Access Compliance Report

Public Rights-of-Way (Curb Ramps)

Intersection ID: 10019134	Main Street: STROUD_PARK_CT	Cross Street: N/A	Location: SW
ADA ID: 6FB664324689	Ramp Type: Perp	Initial Pass/Fail: Fail	Overall Compliance: No
			Severity Score: 10

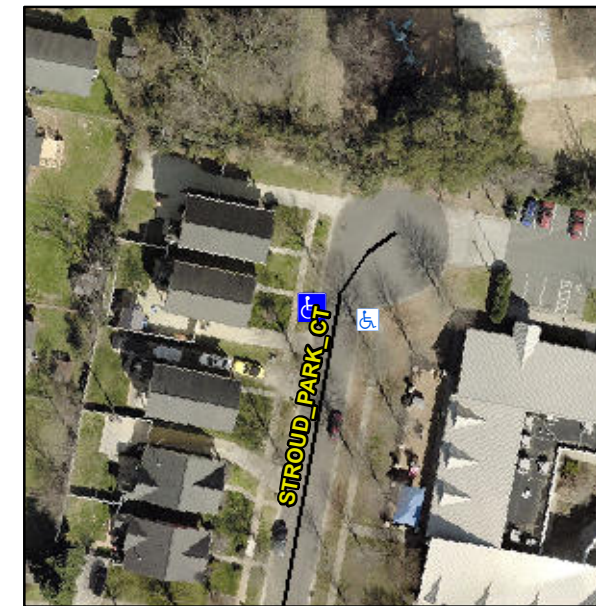
Not Found, R304.5.1, R304.5.3

Compliance	Description	Data	Compliance	Description	Data
N/A	Ramp Length (in)	96.0	Yes	Ramp Slope (%)	7.4
No	Ramp Width (in)	47.5	No	Ramp XSlope (%)	3.6
N/A	Flare Type LT	N/A	N/A	Flare Type RT	N/A
N/A	Flare Slope LT (%)	N/A	N/A	Flare Slope RT (%)	N/A
N/A	Flare Traversable LT?	N/A	N/A	Flare Traversable RT?	N/A
N/A	Landing Length (in)	N/A	N/A	DWS Provided?	N/A
N/A	Landing Width (in)	N/A	N/A	DWS Contrast?	N/A
N/A	Landing Slope (%)	N/A	N/A	DWS Length (in)	N/A
N/A	Landing X Slope (%)	N/A	N/A	DWS Full Width?	N/A
N/A	Landing Curb? (Y/N)	N/A	N/A	DWS Offset (in)	N/A
N/A	Shared Landing?	N/A			
N/A	Gutter Ponding?	N/A	N/A	Gutter Slope (%)	N/A
N/A	Gutter Lip Ht (in)	N/A	N/A	Gutter X Slope (%)	N/A
N/A	Painted X Walk1?	No	N/A	Painted X Walk2?	N/A
	X Walk 1 Direction	To SE		X Walk 2 Direction	N/A
N/A	X Walk 1 Width (in)	N/A	N/A	X Walk 2 Width (in)	N/A
	X Walk 1 Slope (%)	3.7		X Walk 2 Slope (%)	N/A
	X Walk 1 X Slope (%)	1.1		X Walk 2 X Slope (%)	N/A

Remove & Replace Entire Ramp.
